ADDENDUM NO. 1

STEPHEN DECATUR PARK COMFORT STATION
TOWN OF BERLIN
WORCESTER COUNTY, MARYLAND
DBF #0050A115
September 14, 2022

CMU SILL DIMENSIONS
SCALE 3" =1'-0"

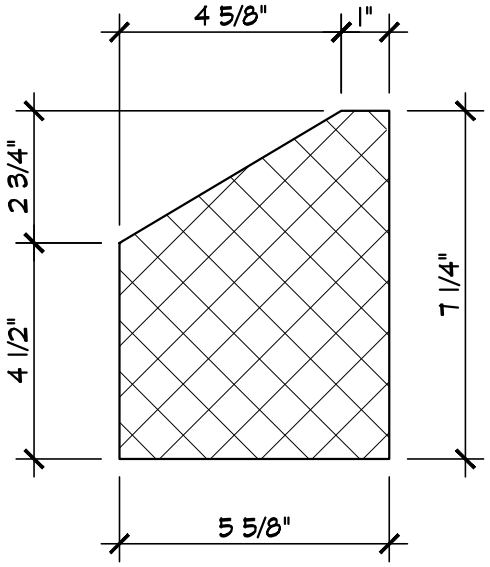
19. **Referencing sheet A3.1 detail 011 and sheet A3.2 detail 010, can we get a dimensional size of the Pre-Cast Sill?**
    a. Please see the attached ADD1 SK 1 dated 9/13/2022

Proj.No.: 0050A115.A01 | Scale: AS NOTED | Sheet No.: A1.1

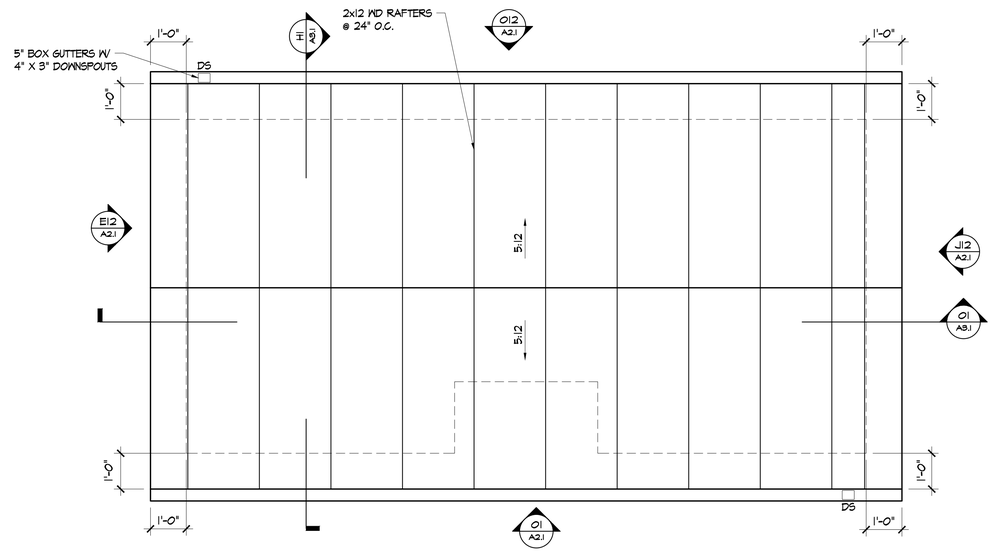
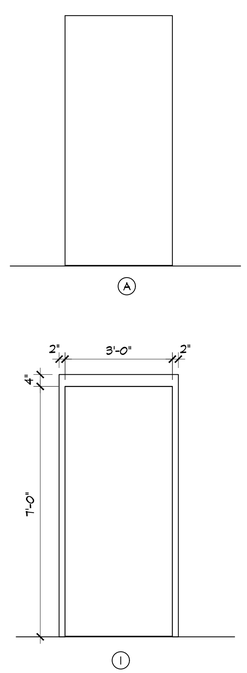
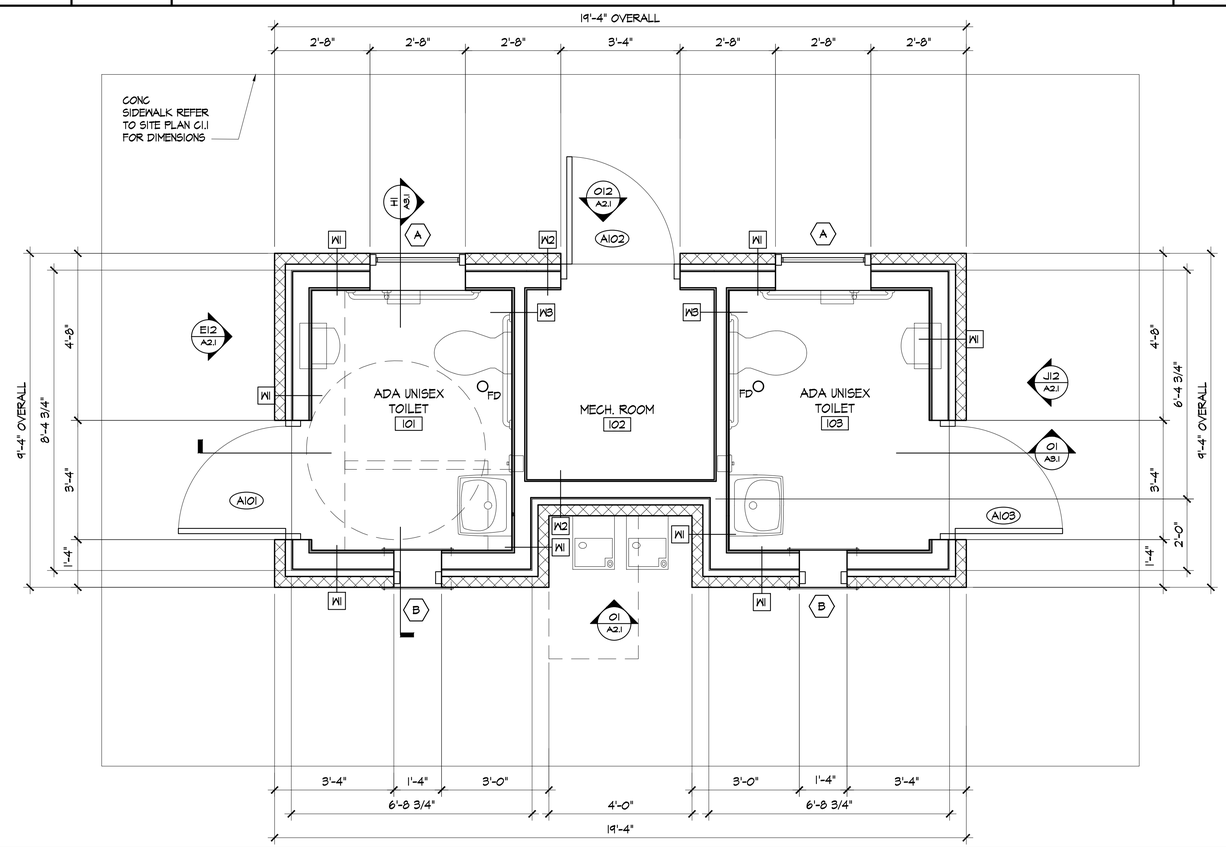
1. Sheet A1.1 has been revised to reflect a change in the locking hardware being proposed.

PROPOSED SITE PLAN

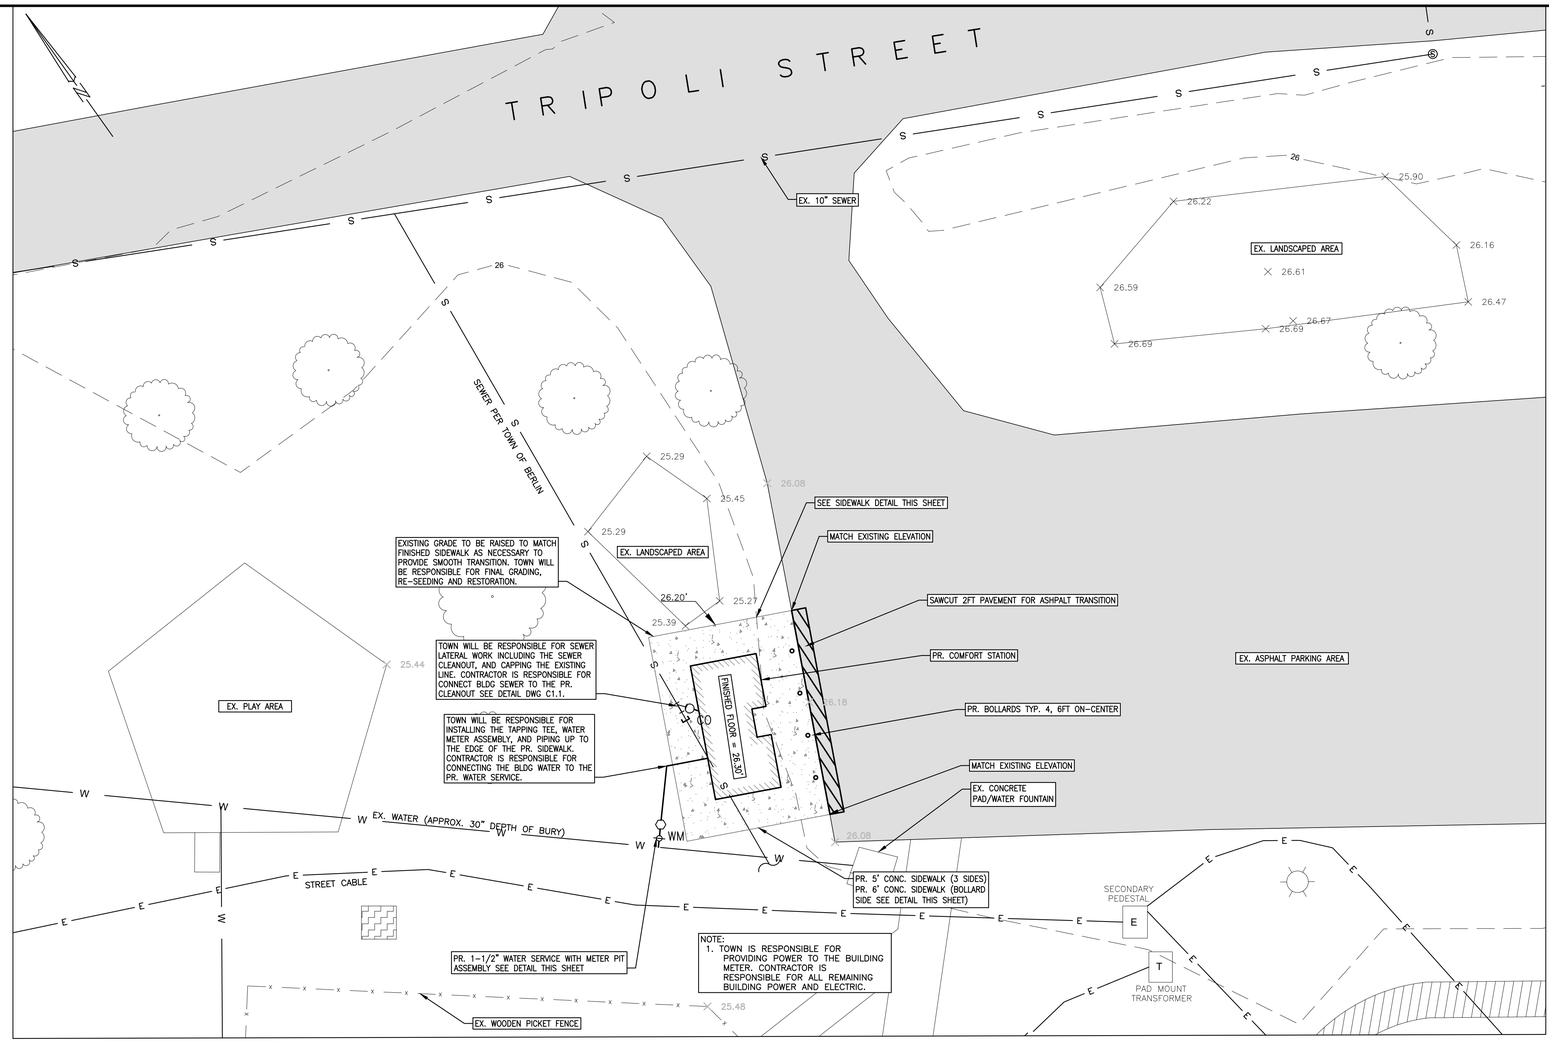
2. Please confirm location/routing of electric service to the new building, does not appear to be shown on any site plans.

a. The Town will run a new electric service from the secondary pedestal shown on sheet C.1 to the vicinity of the building. This will act as a temporary and eventual permanent service. Please review the note on C.1 'Town is responsible for providing power to the building meter. Contractor is responsible for all remaining power and electric.'. The Town shall coordinate this work with the Contractor during construction.

CURB STOP & METER ASSEMBLY DETAIL

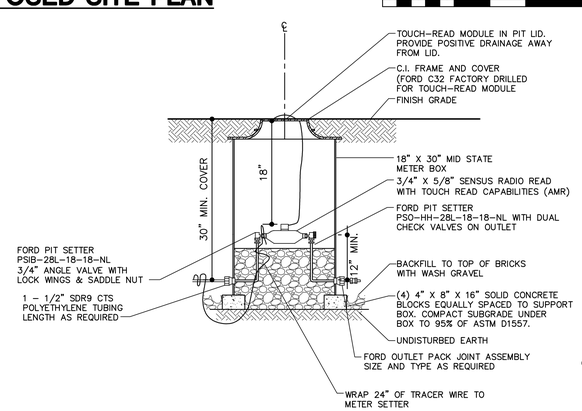
6. **Referencing sheet C.1 Curb Stop And Meter Assembly Detail and the Plumbing Series of documents. It is stated in note #2 of the Curb Stop And Meter Assembly Detail that fire service shall be provided separately and the plumbing drawings per sheet P0.1 make mention of a sprinkler and flow tamper switch. I do not see any code in the documents indicating a fire suppression system is required here (Note: Typically NFPA 13 is utilized in this case). Can you please confirm there is no requirement for a fire suppression system. If it is required please provide where the riser pipe will need to be brought in and if a fire pump and if any other requirements are necessary.**
   a. This project does not require a fire suppression system.

SIDEWALK TIE-IN DETAIL

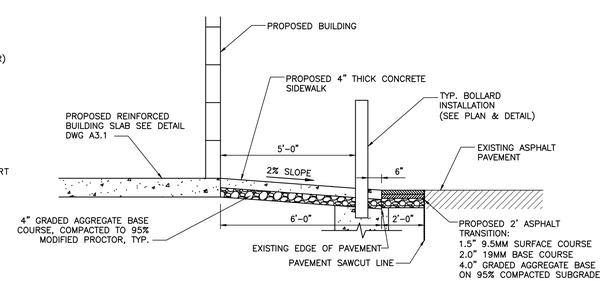
24. Please confirm that the Town will furnish and install the new concrete sidewalks in their entirety as the site plan states the proposed 4" Sidewalk is to be by the town, however the RFP calls for the GC to include both the concrete and the new asphalt transition.

26. Please clarify if the GC is to provide the new site concrete for this project and if so, to what extent? The drawings on Cx.1 show the 4" concrete sidewalk to be by the town in detail "Sidewalk Tie-In Detail" however it appears that per the "Site Plan" and "Sidewalk Detail" seem to convey that this work is to be done by the GC.

2. Sheet C.1 has been revised to reflect a change in the 'Sidewalk Tie-in Detail'.

a. The Town will not furnish and install the new concrete sidewalks, the Contractor is to include all new site concrete work and the new asphalt transition. Please see the attached sheet C.1 with a revised 'Sidewalk Tie-in Detail'.

a. The Contractor is to provide all new site concrete for the sidewalk and building for this project.
